INDIANA DEPARTMENT OF TRANSPORTATION

AGENDA

February 17, 2011 Standards Committee Meeting

RE: Agenda for the February 17, 2011 Standards Committee Meeting

601-RPPG-01 ROADSIDE PIER PROTECTION GUARDRAIL

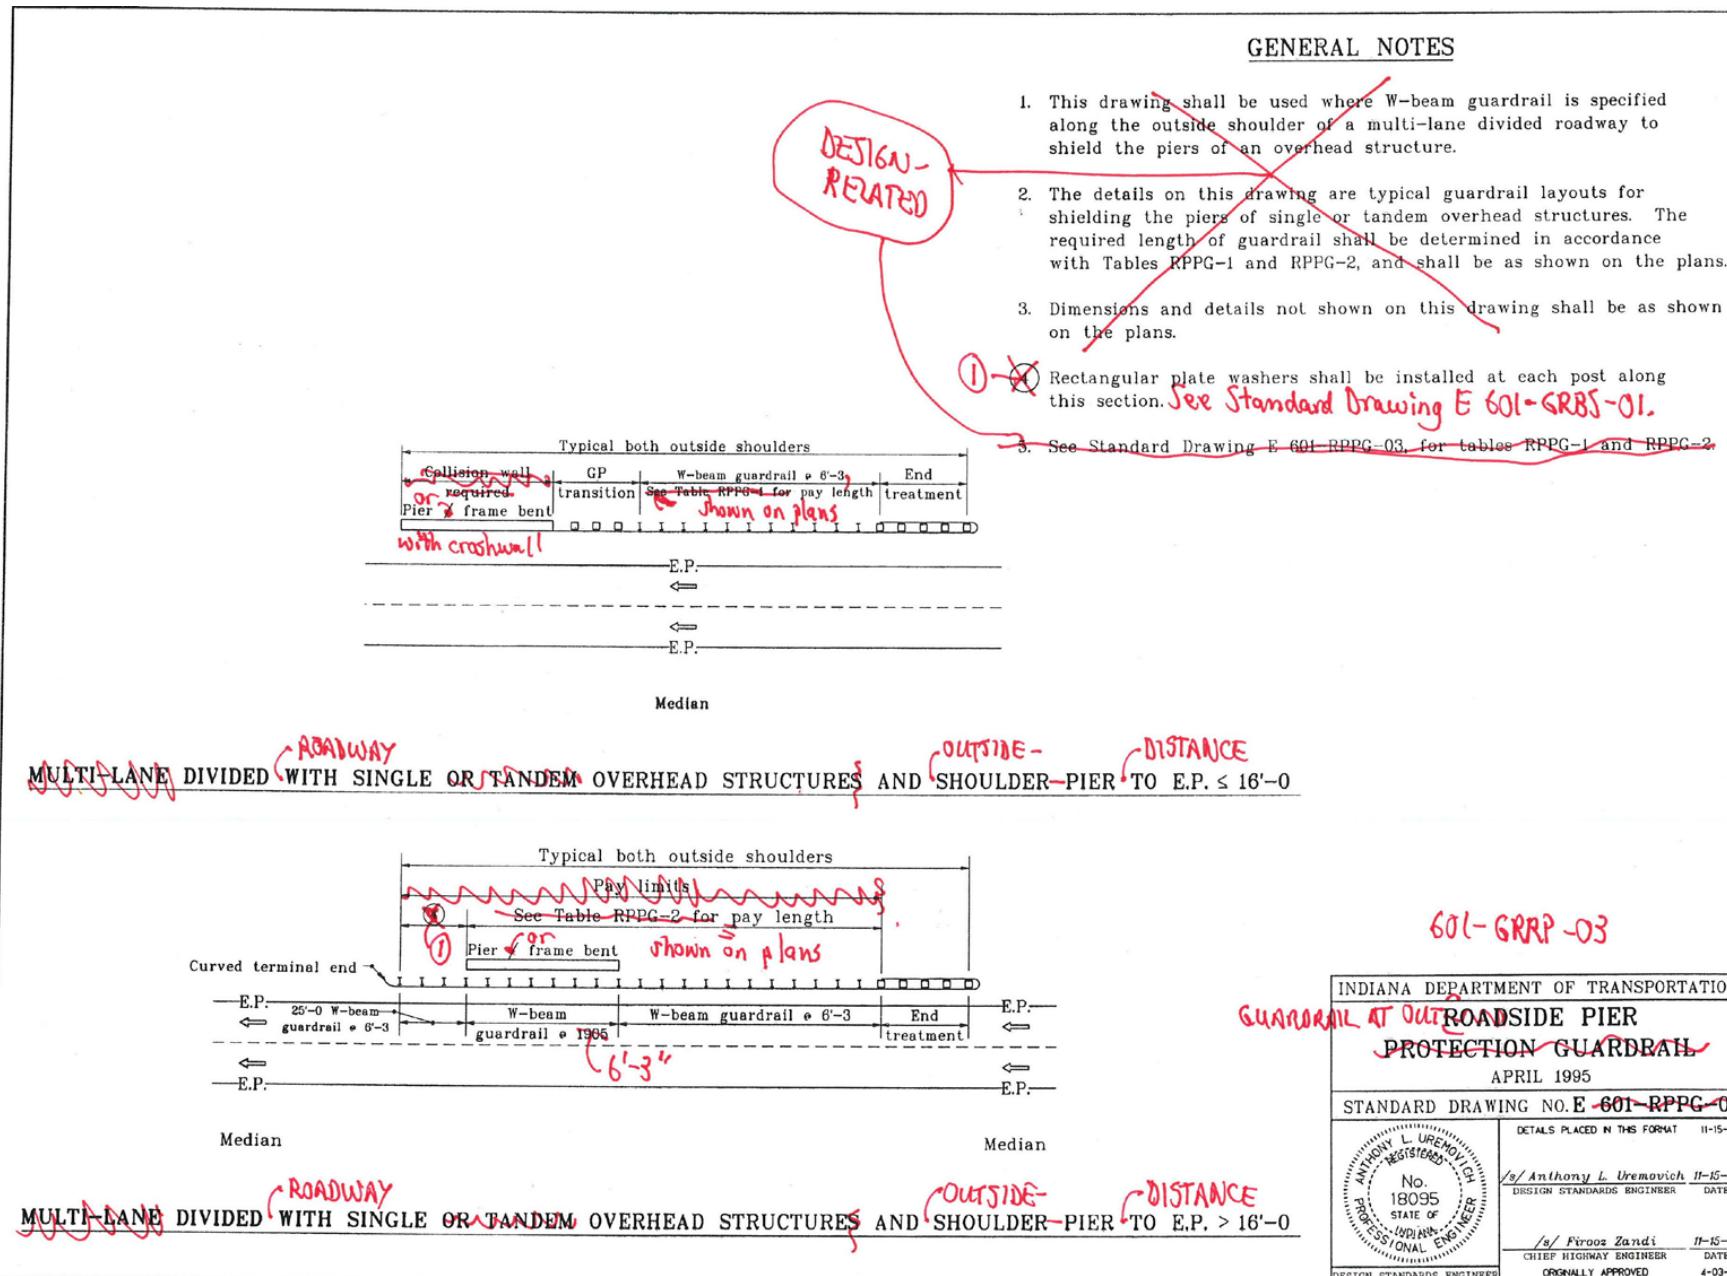
REVISION TO STANDARD DRAWINGS

601-RPPG-02 ROADSIDE PIER PROTECTION GUARDRAIL

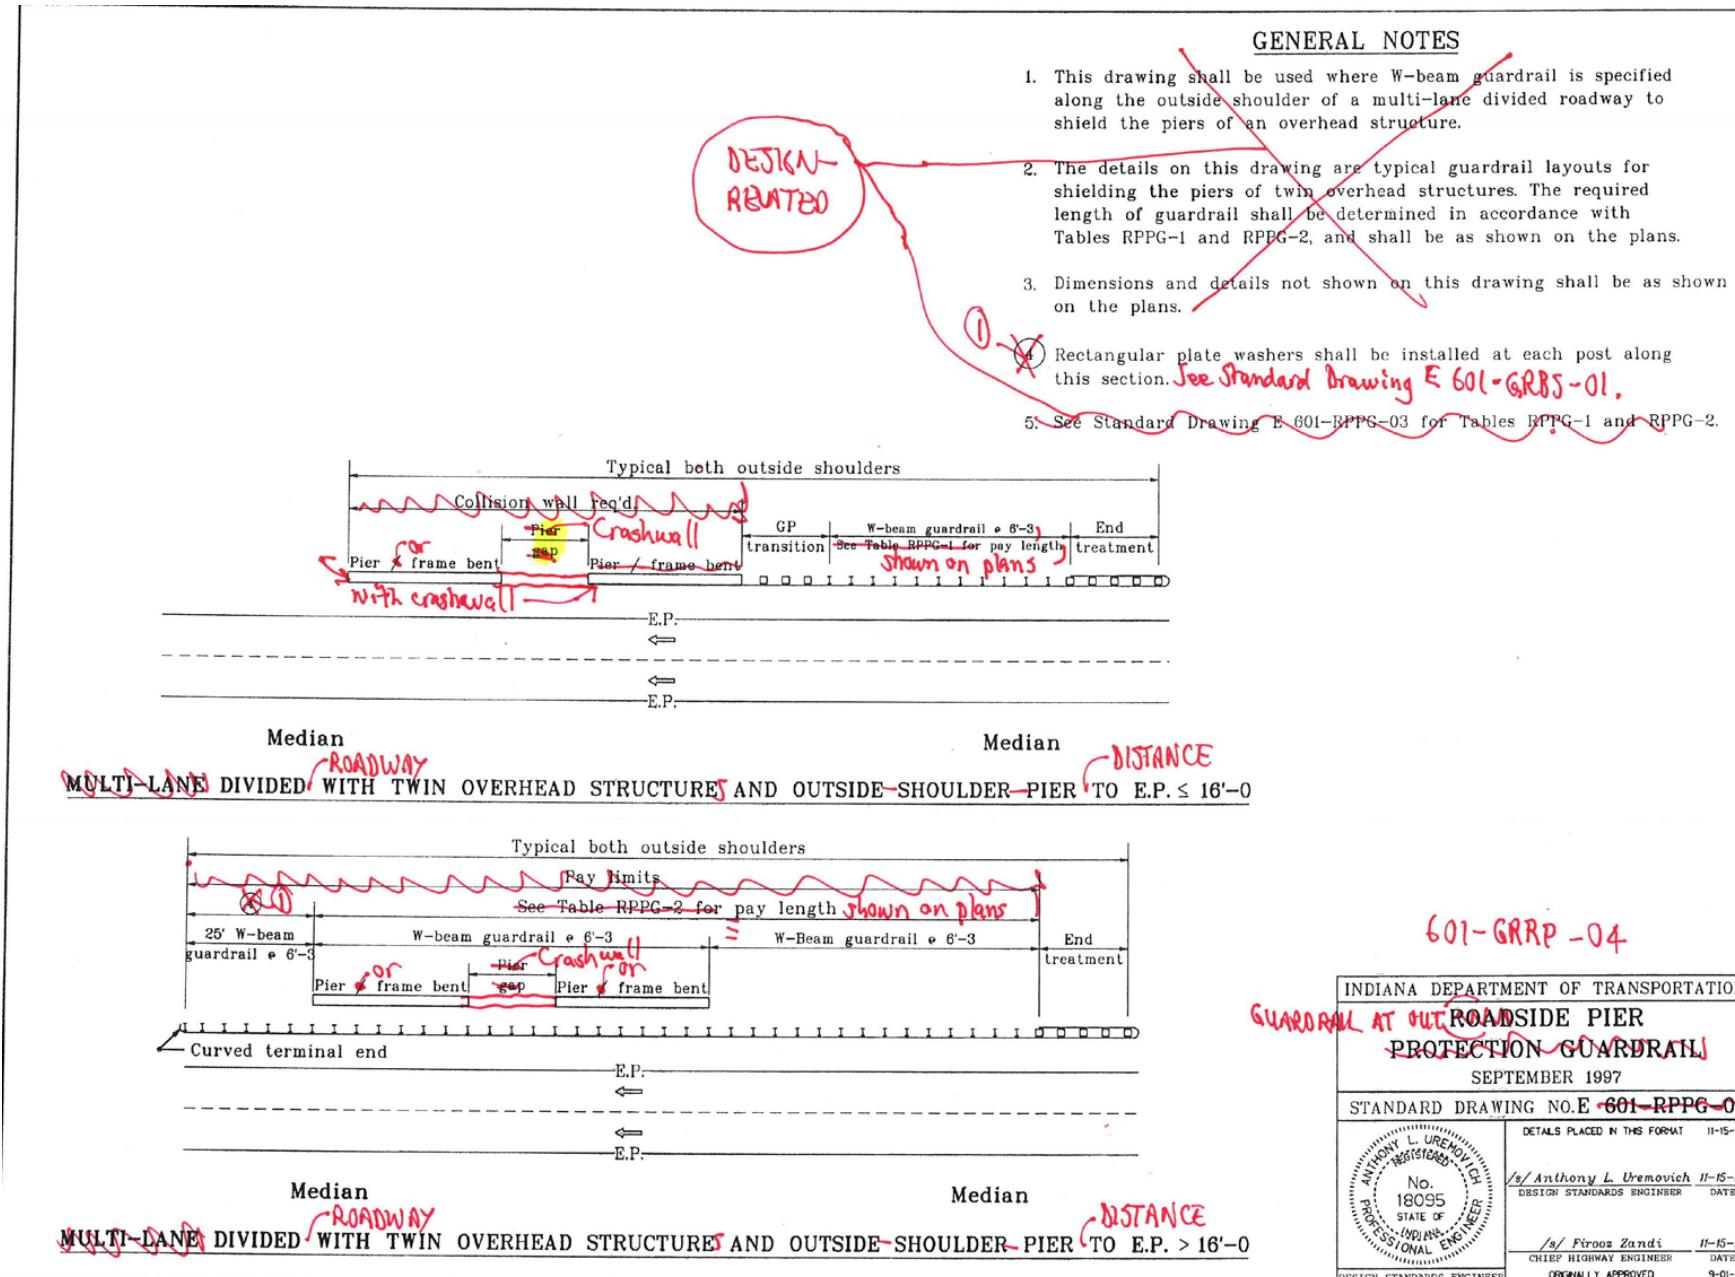
REVISION TO STANDARD DRAWINGS

601-MPPG-04 MEDIAN PIER PROTECTION GUARDRAIL

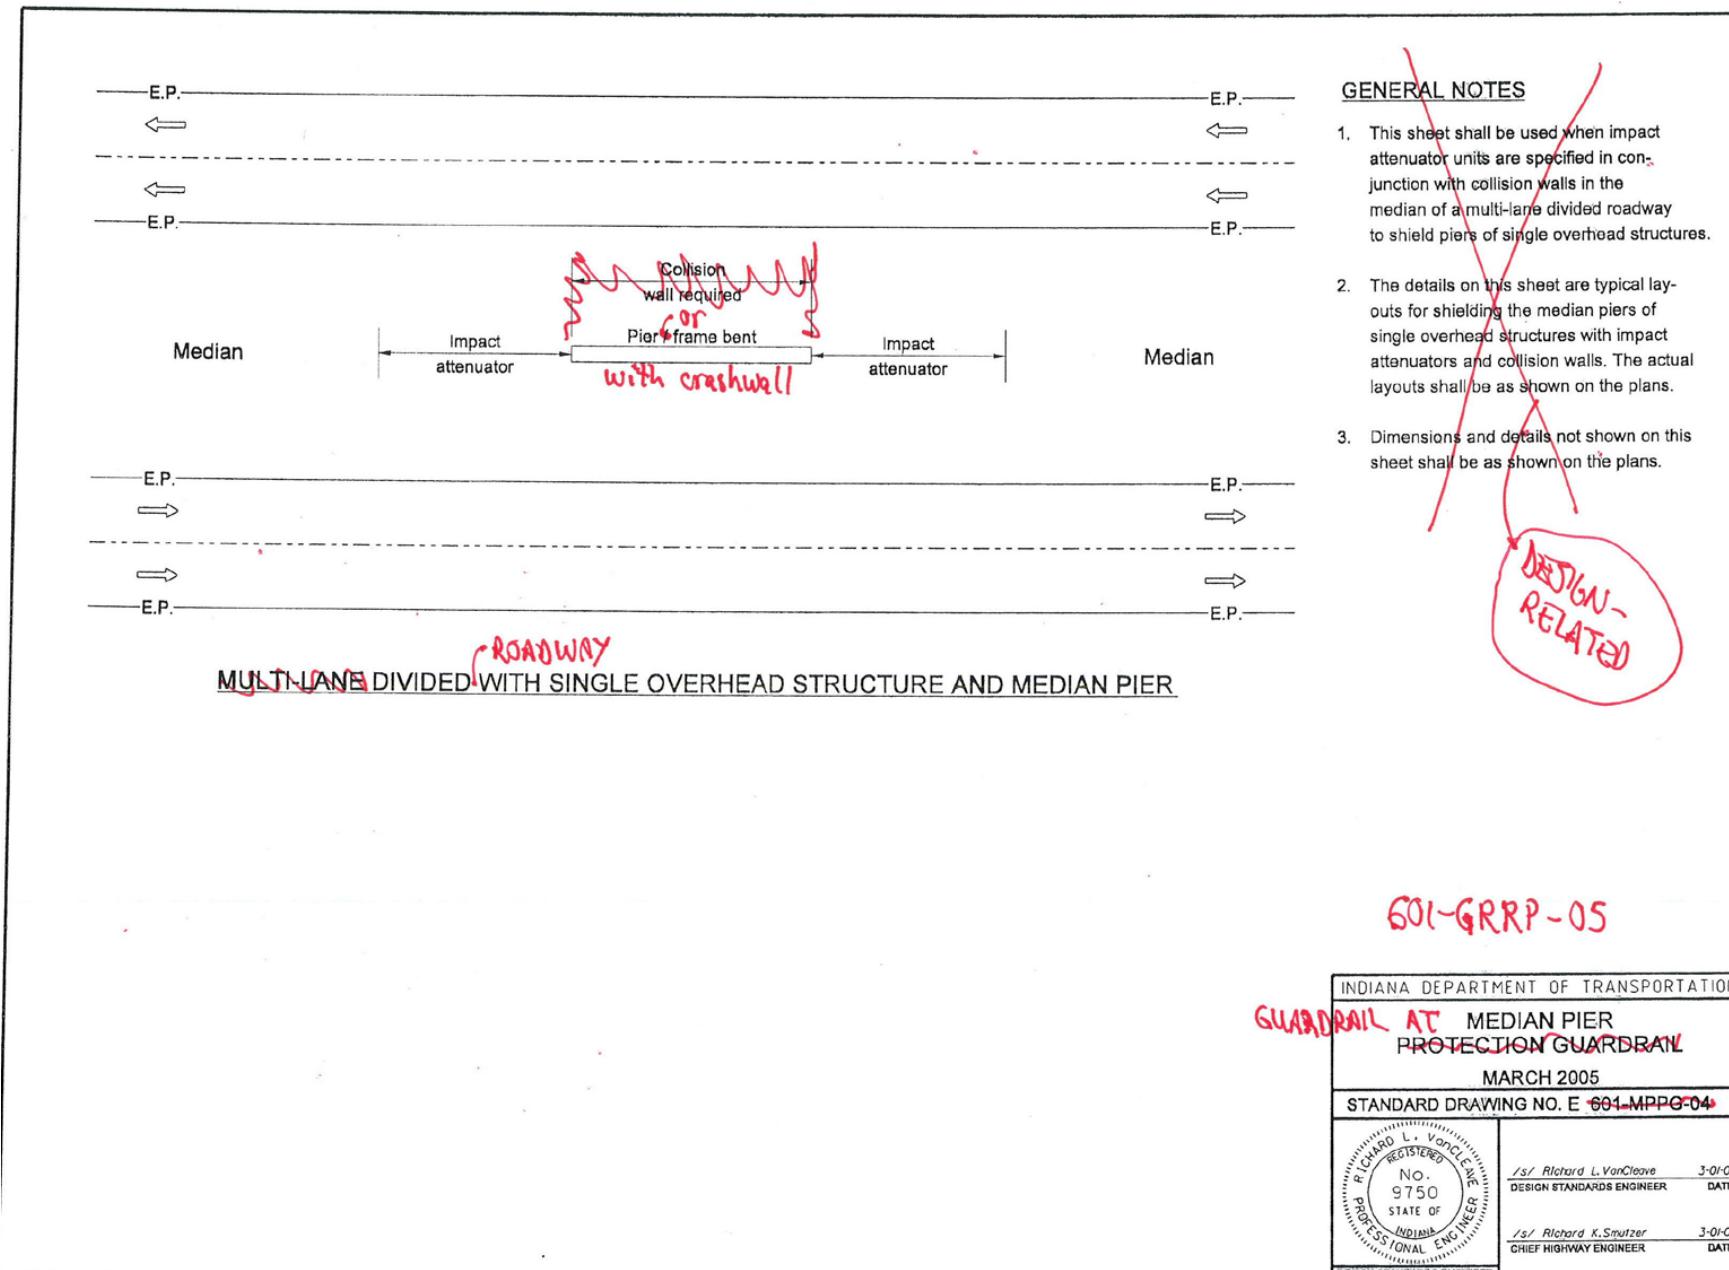
REVISION TO STANDARD DRAWINGS

601-MPPG-03 MEDIAN PIER PROTECTION GUARDRAIL

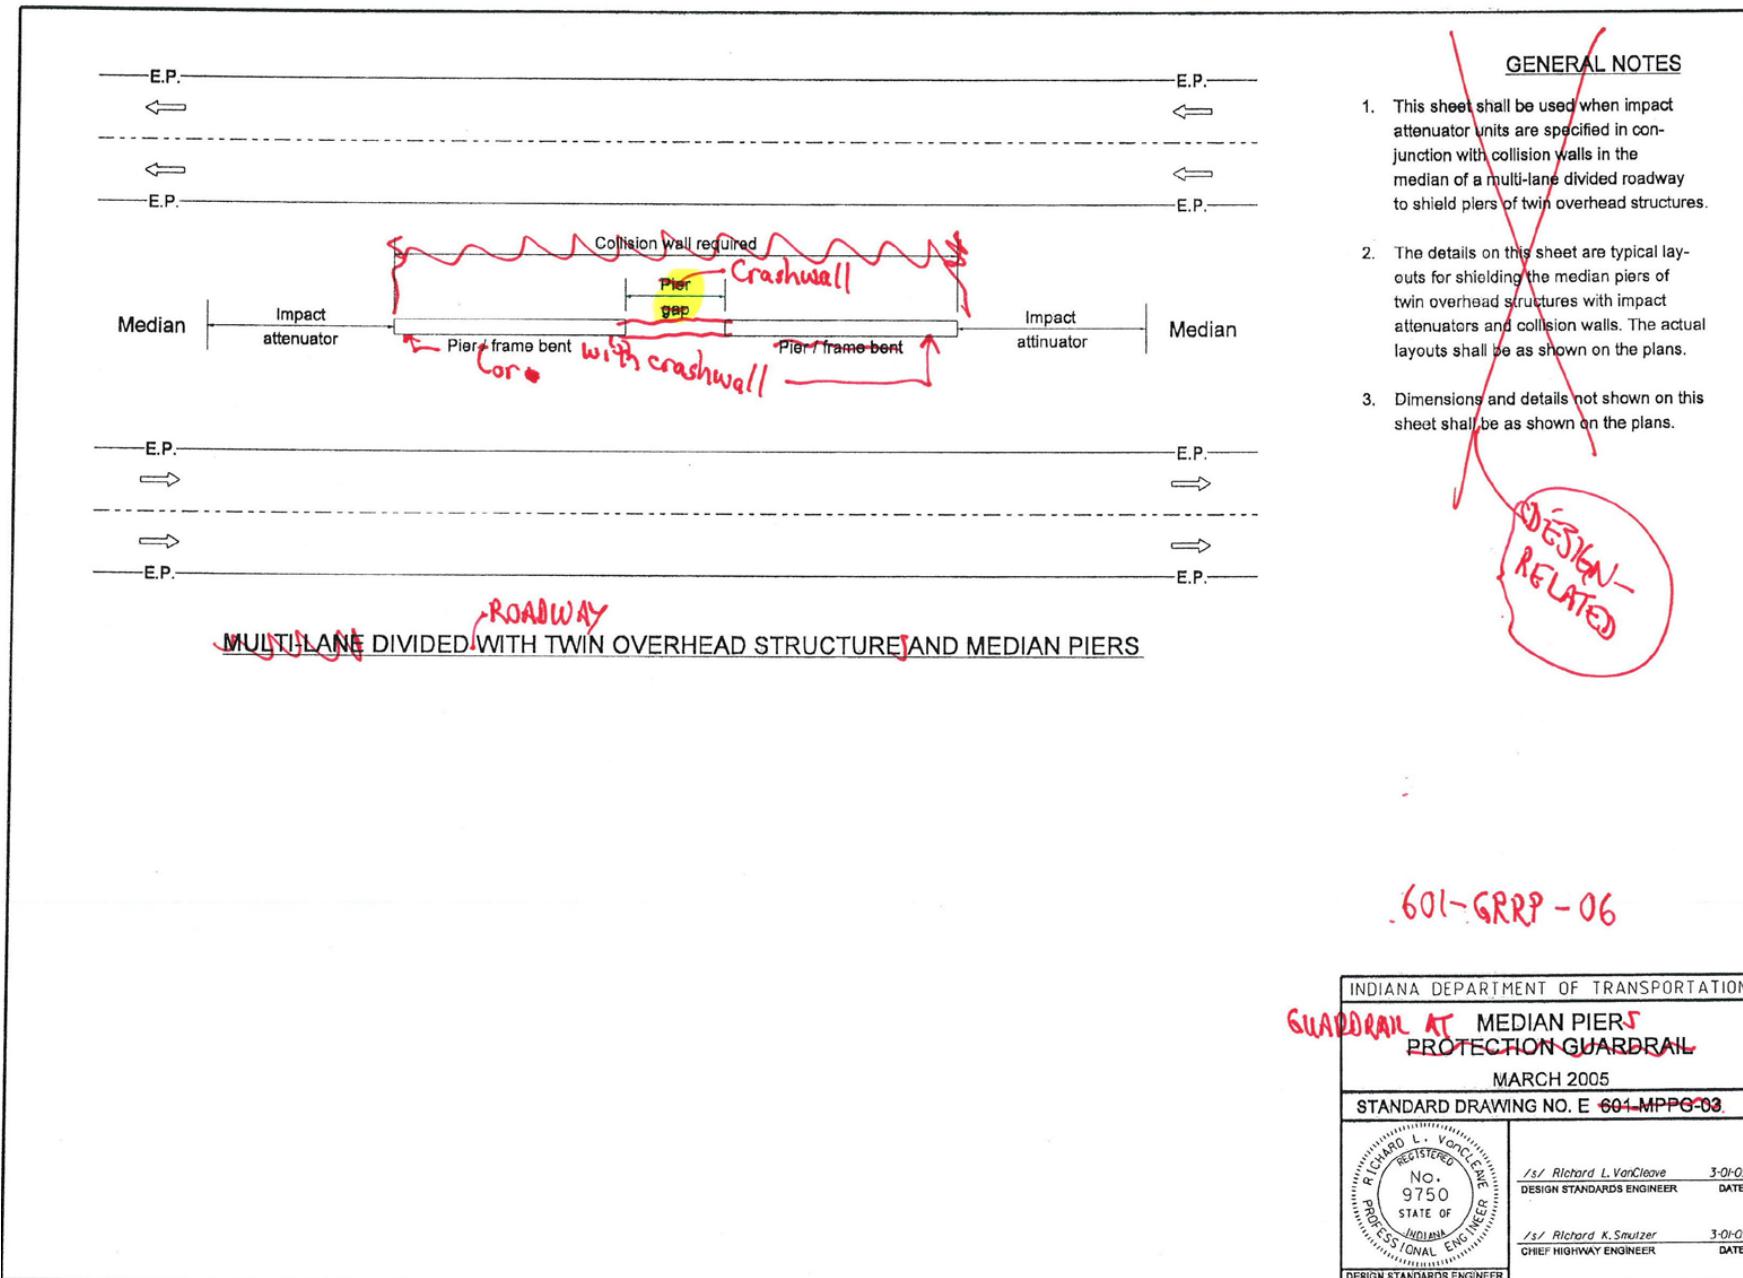
REVISION TO STANDARD DRAWINGS
